*Replace 85.8.3.2 with the following:*

### 85.8.3.2 Transmitted output waveform

**Figure 85–3 – Transmit equalizer functional model**

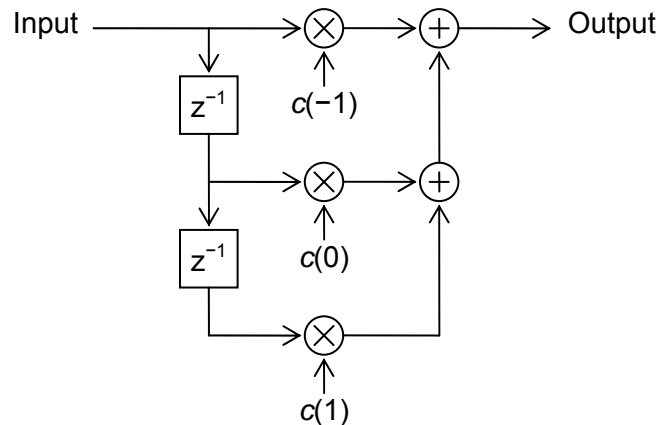
The 40GBASE-CR4 and 100GBASE-CR10 transmit function includes programmable equalization to compensate for the frequency-dependent loss of the channel and facilitate data recovery at the receiver. The functional model for the transmit equalizer is the three tap transversal filter shown in Figure 85–3.
